**Bid 643**  
**New HVAC Modernization Project for Rio Mesa High School**

**BID CLARIFICATION ADDENDUM #1**

Dated: December 30, 2020

- 3) Please refer to **Attachment B** for Architect's addendum 1

|   | RMHS ALTERATION PROJECT<br>for<br>OUHSD<br>545 CENTRAL AVE<br>OXNARD, CA 93036 | <small>Date</small><br>12/22/2020<br><small>Job No.</small><br>2847.0200<br><small>Sheet No.</small><br>A1.01 |

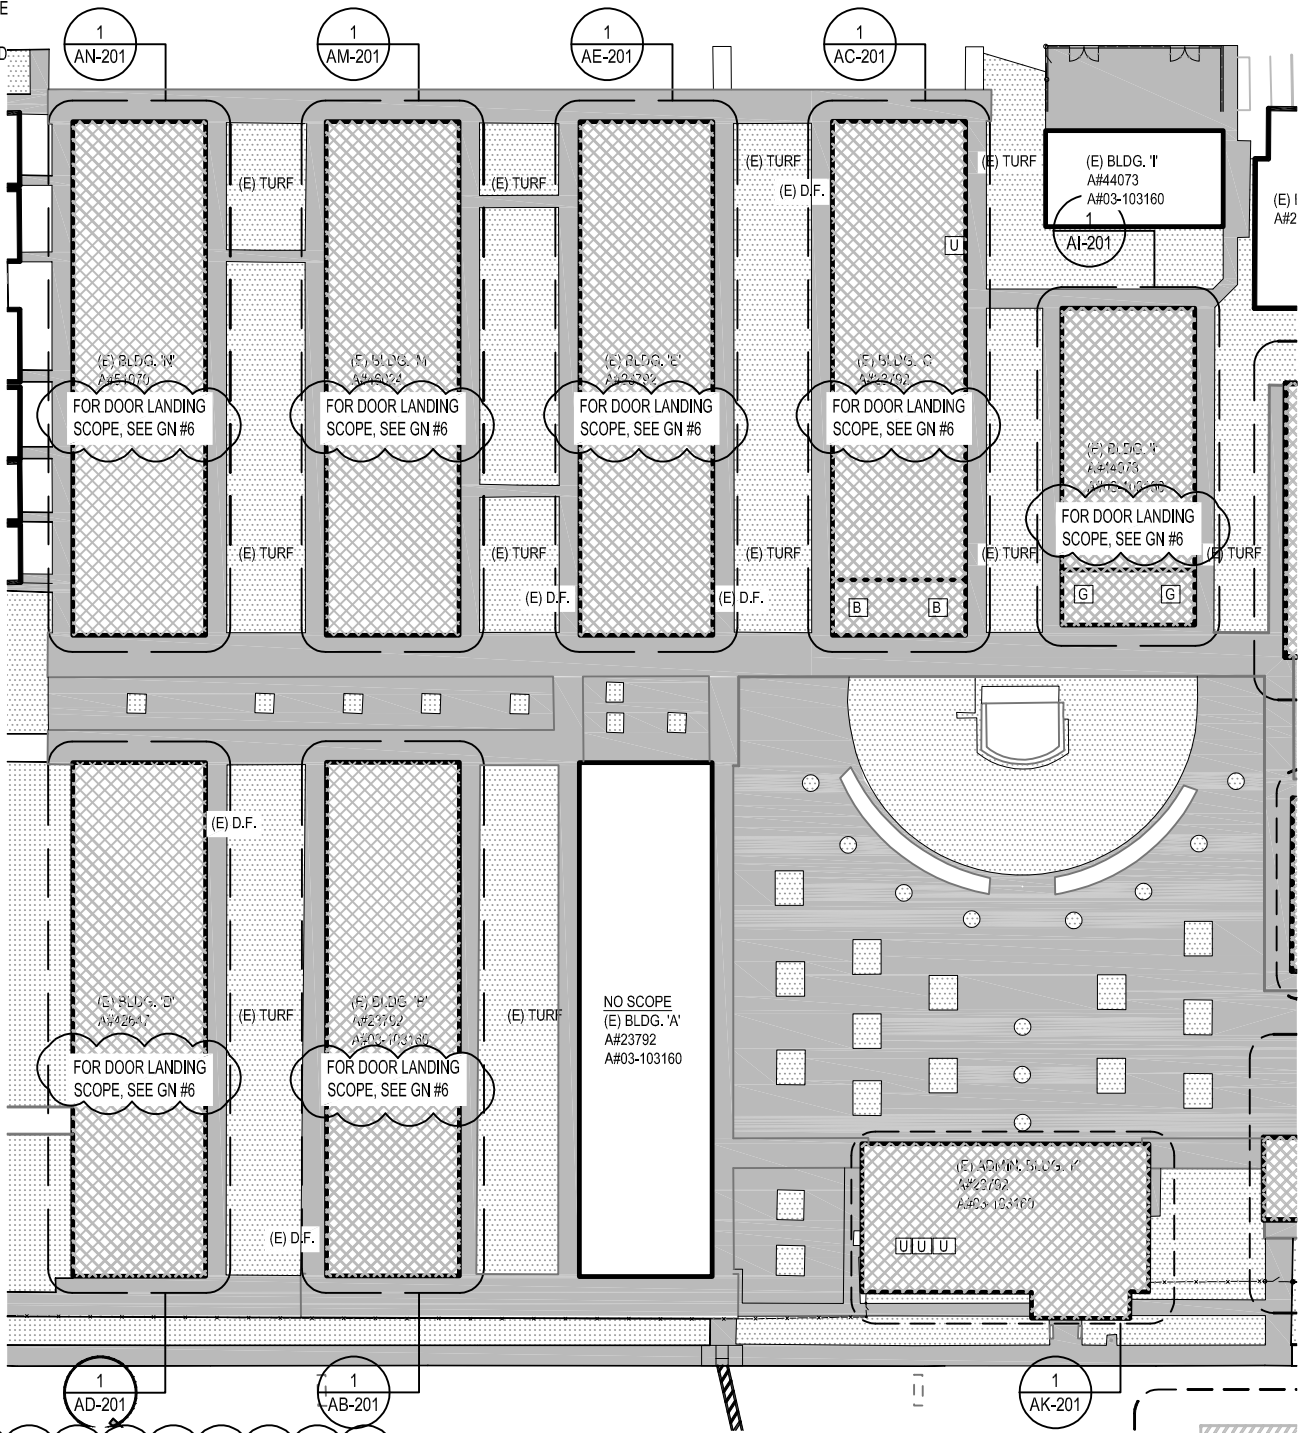
2. **Sheet A1.01**
- a. **Add** note: "G.C. shall Patch & Repair existing built up roof membranes & existing roof shingles affected by project scope. Refer to Roof Type Table for roof type at each building. See typical roof details on sheet A9.04. Provide a separate square foot unit cost for cover board, insulation board, and sheathing replacement." See attachment 1A.

- c. **Add** note: "Provide Transom Infill as per Addendum No.1 detail 14/A9.02 at all exterior doors buildings B, C, D, E, I, M, and N"
  - d. **Add** notes to sheet A1.01 as shown in the clouded areas on Addendum No. 1 detail 1/-.

| Sheet No. | A1.05      |

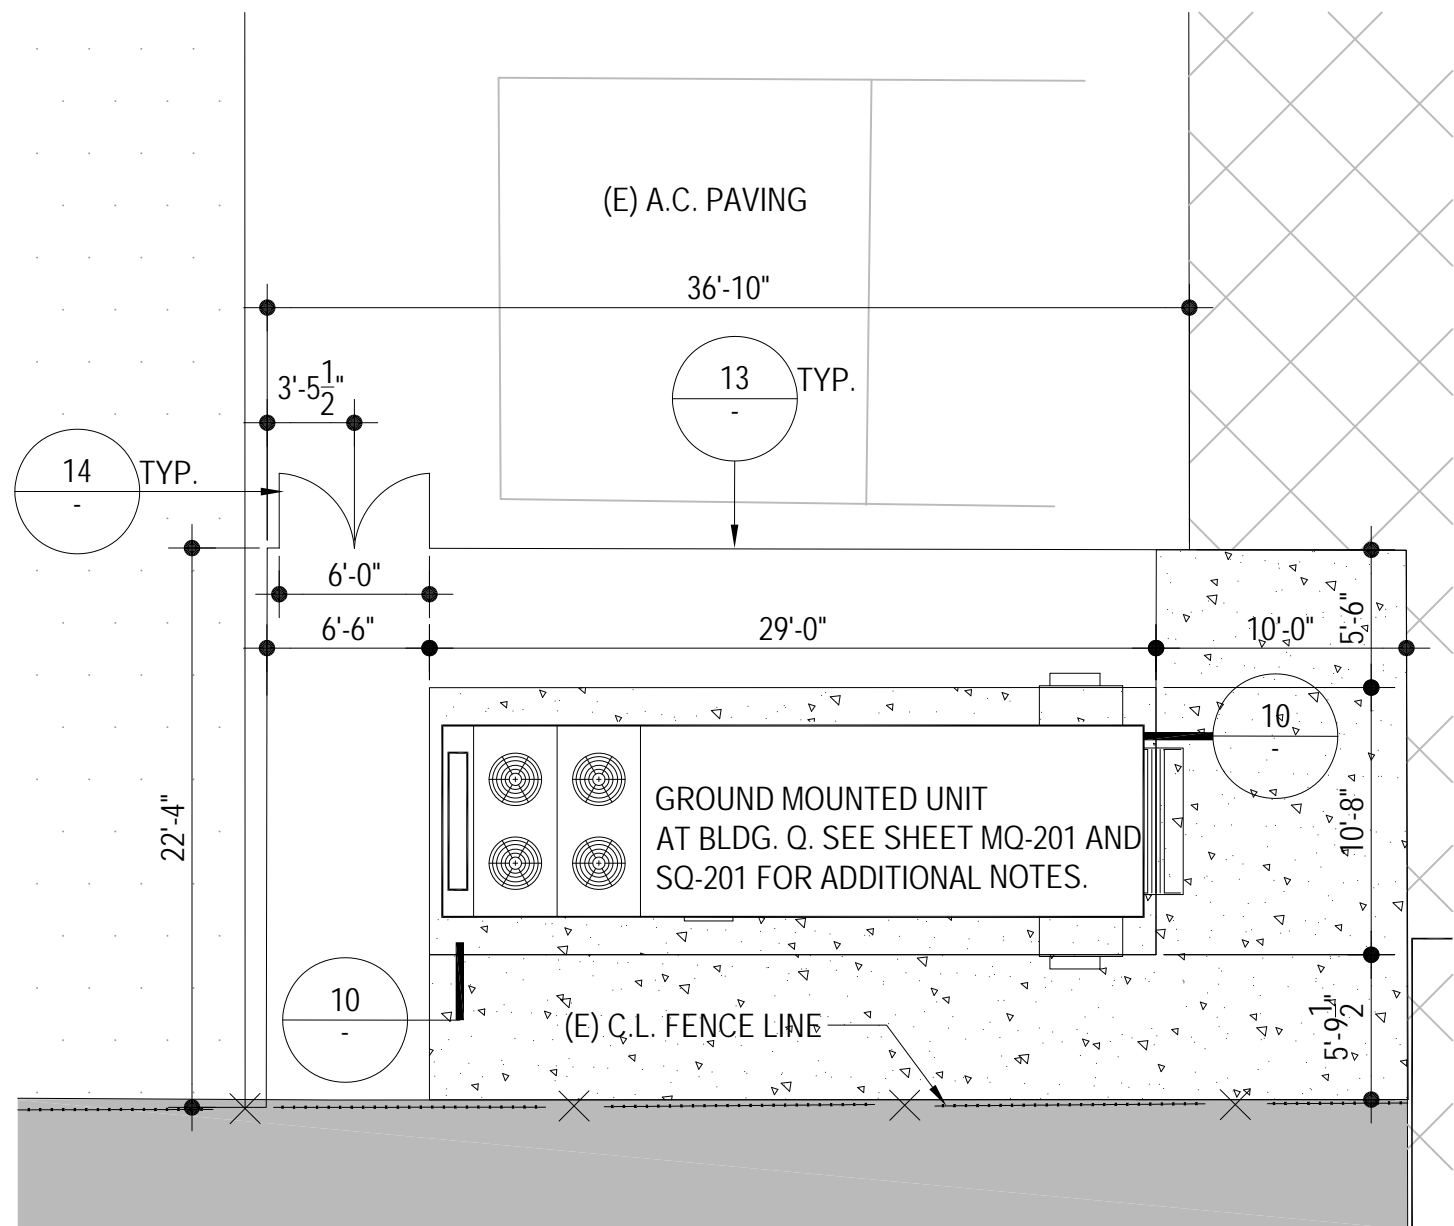
3. **Sheet A1.05**
- a. **Replace** detail 10/A1.05 in its entirety with Addendum No.1 detail 10/-.
  - b. **Replace** detail 11/A1.05 in its entirety with Addendum No.1 detail 11/-.

| Sheet No. | A9.02      |

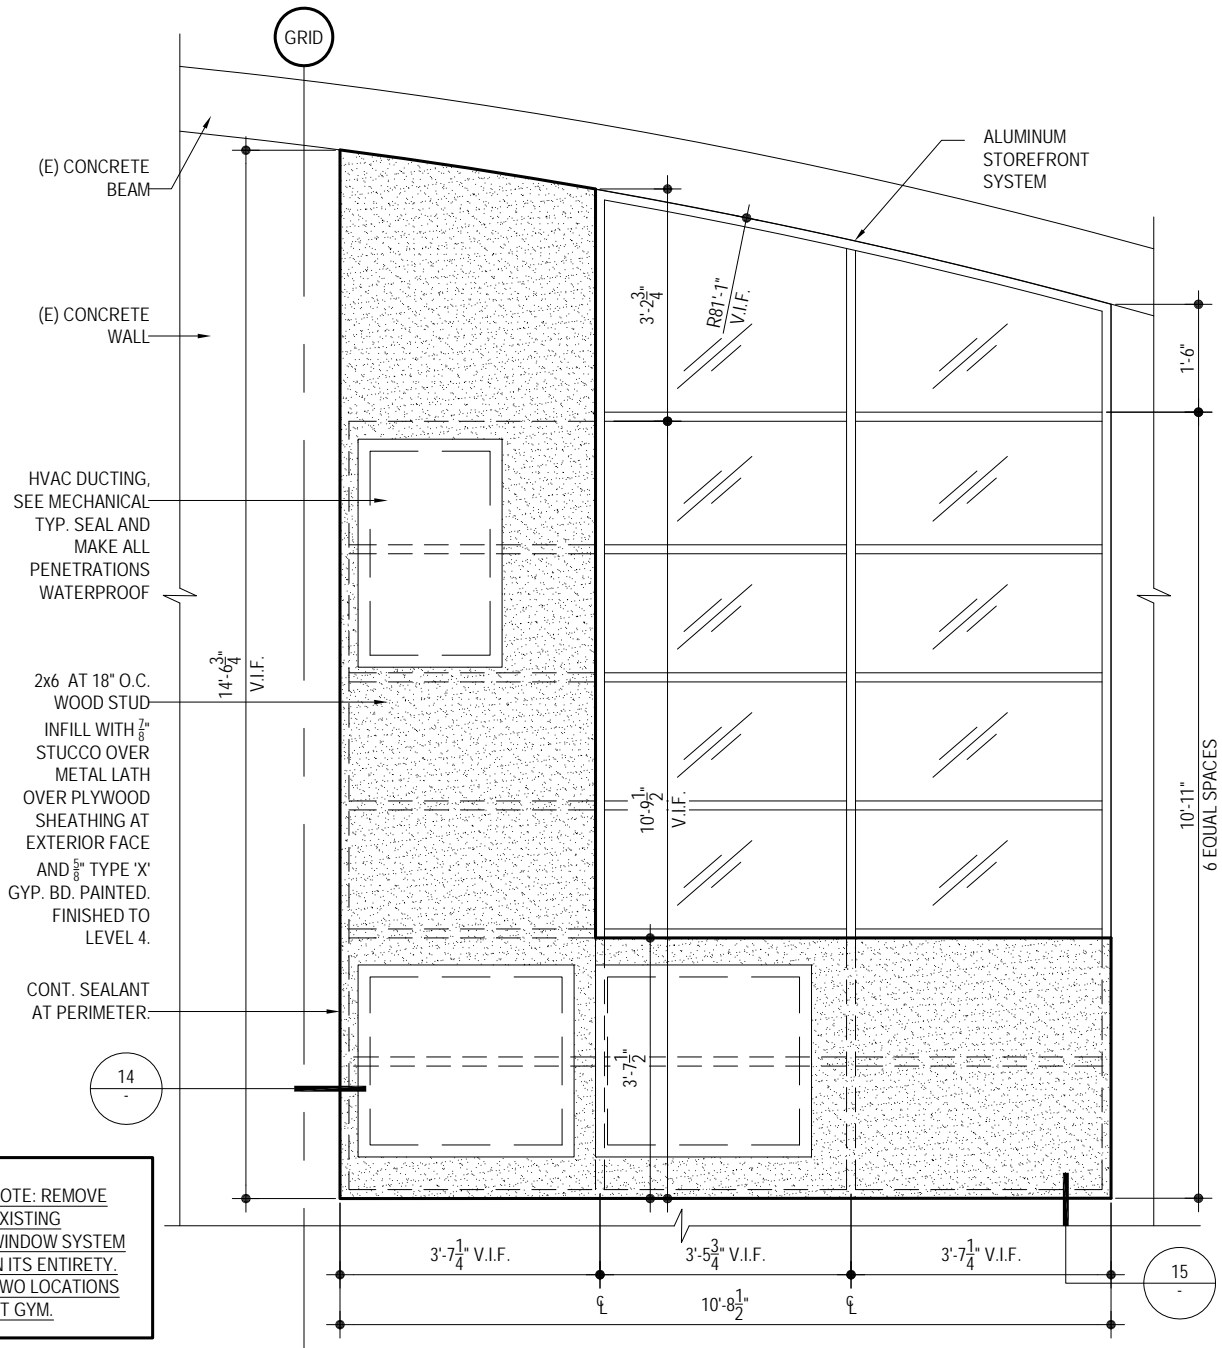
4. **Sheet A9.02**
- a. **Add** Addendum No. 1 detail 14/- to Sheet A9.02.
5. **Sheet A9.03**
- a. **Replace** detail 13/A9.03 in its entirety with Addendum No. 1 detail 13/-.

| Sheet No. | A9.03      |

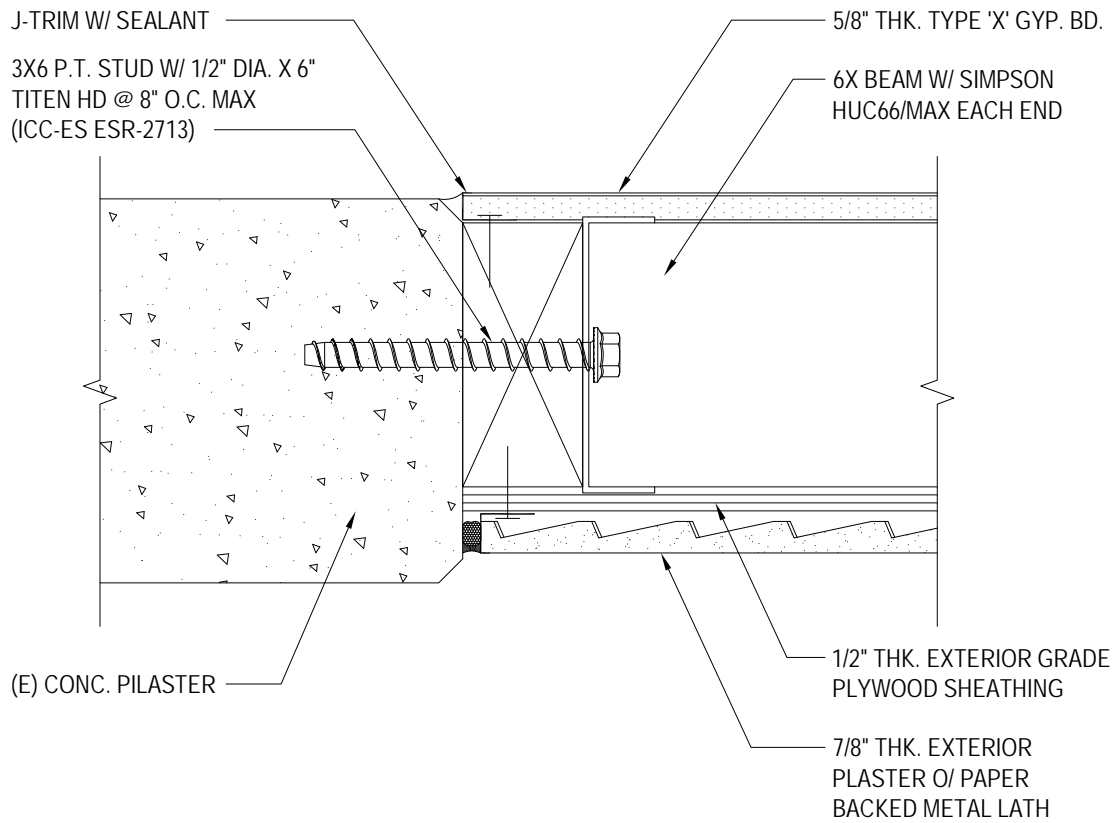
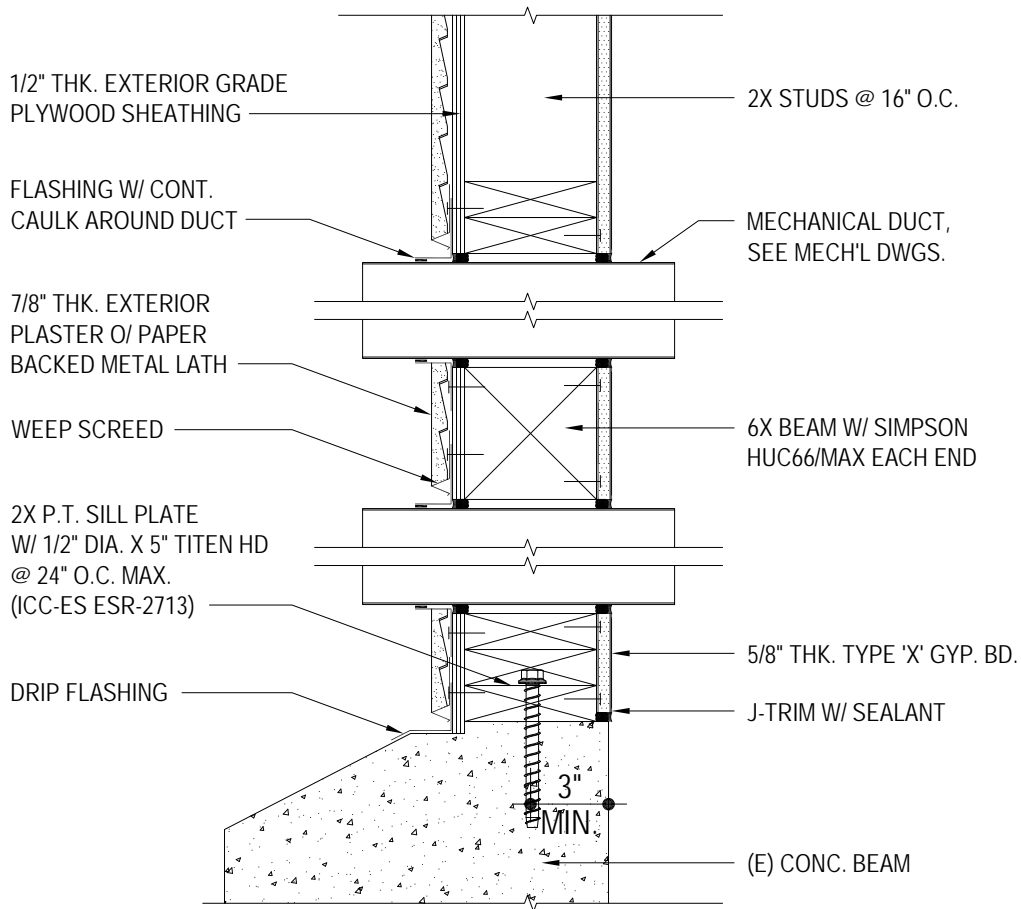
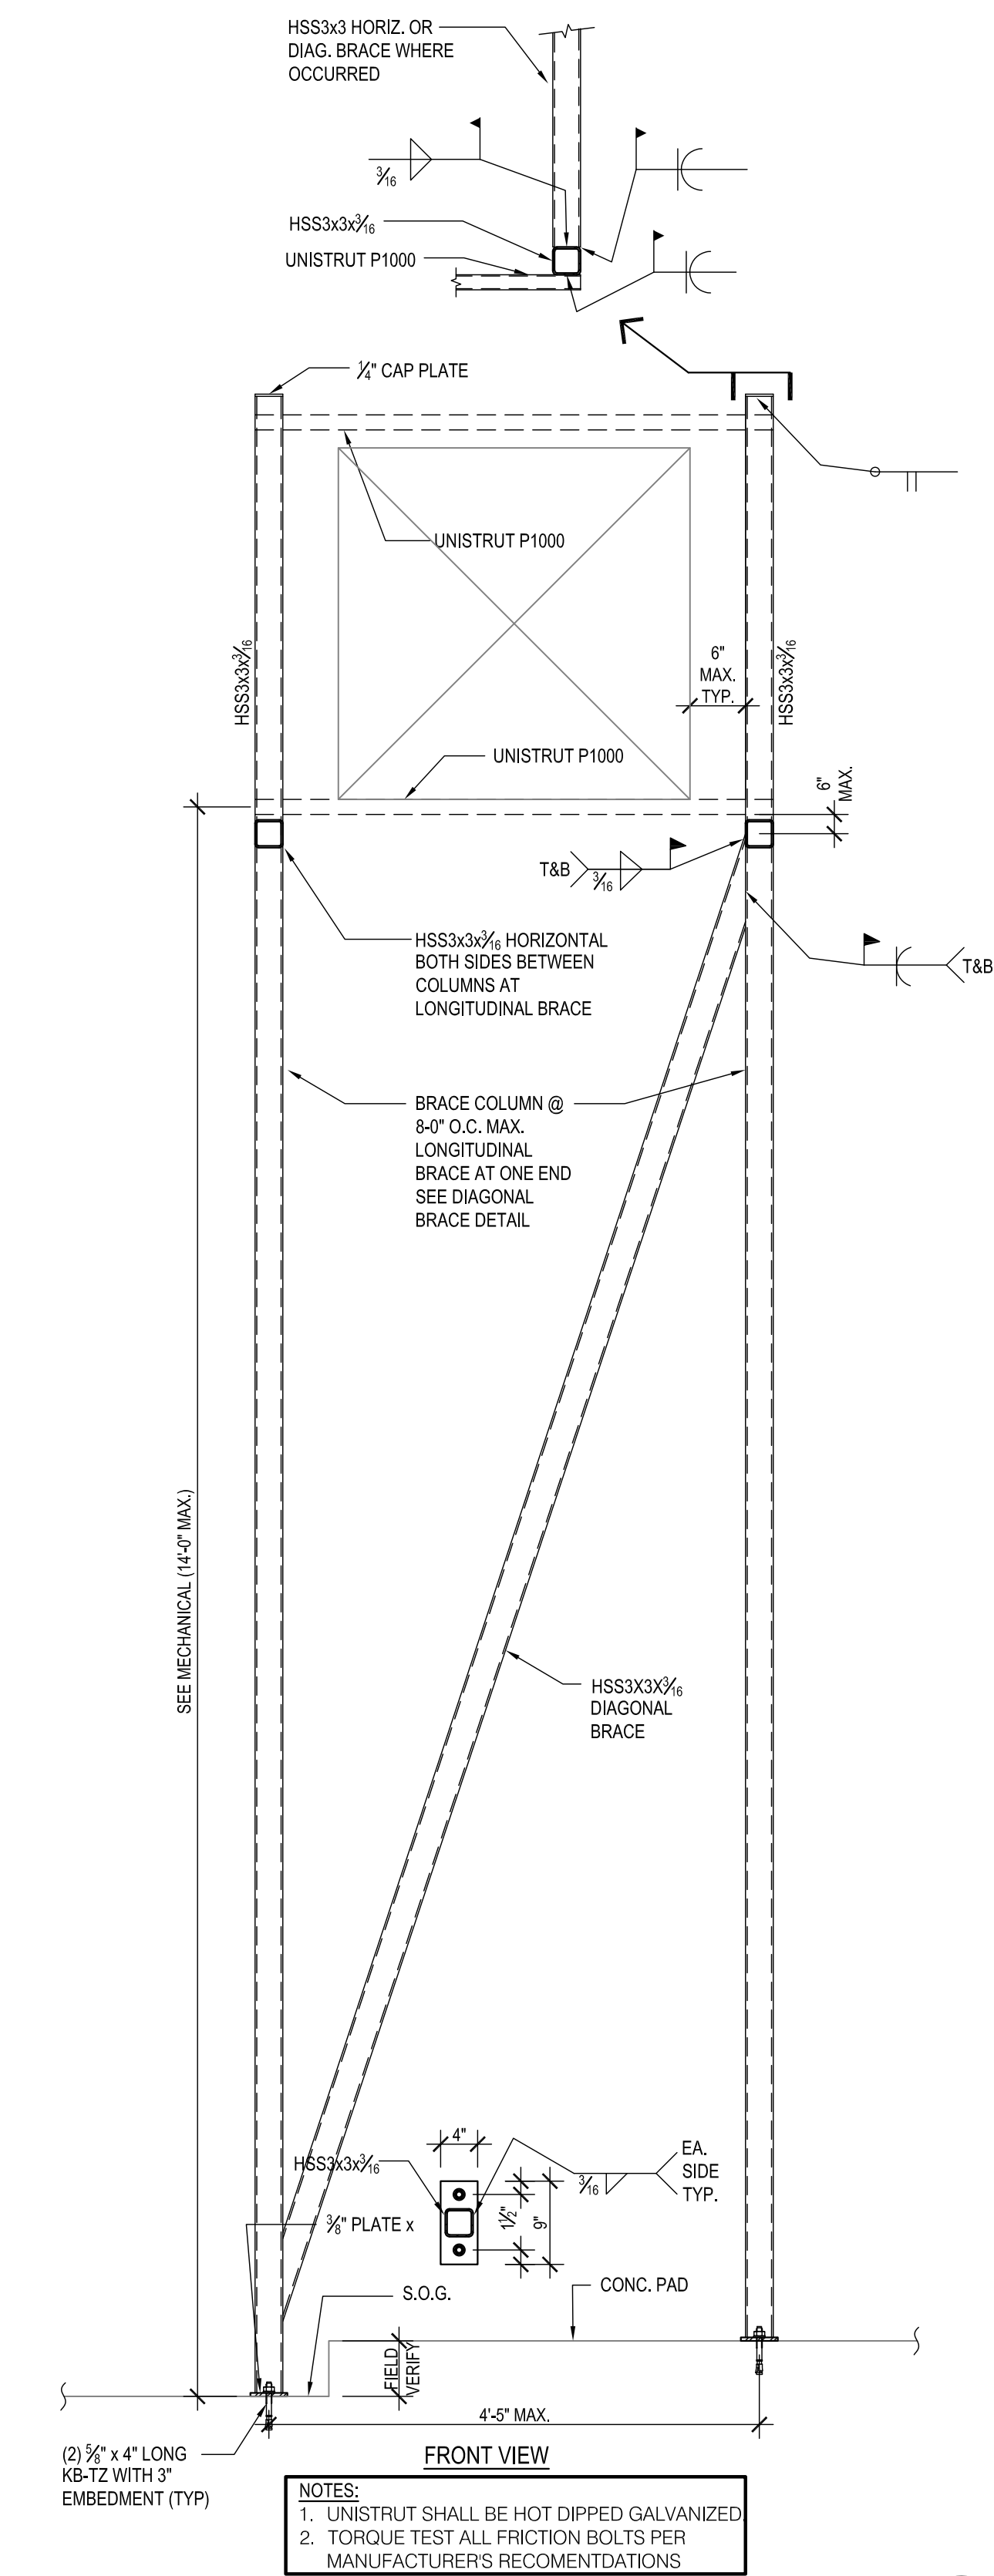
- b. **Add** detail 14/A9.03 as per Addendum No. 1 detail 14/-.
  - c. **Add** detail 15/A9.03 as per Addendum No. 1 detail 15/-.
6. **Sheet S-102**
- a. **Add** note to detail 7/S102 to read "For thickened edge and additional requirements at RTU Q-1 equipment pad, see 10/A1.05"
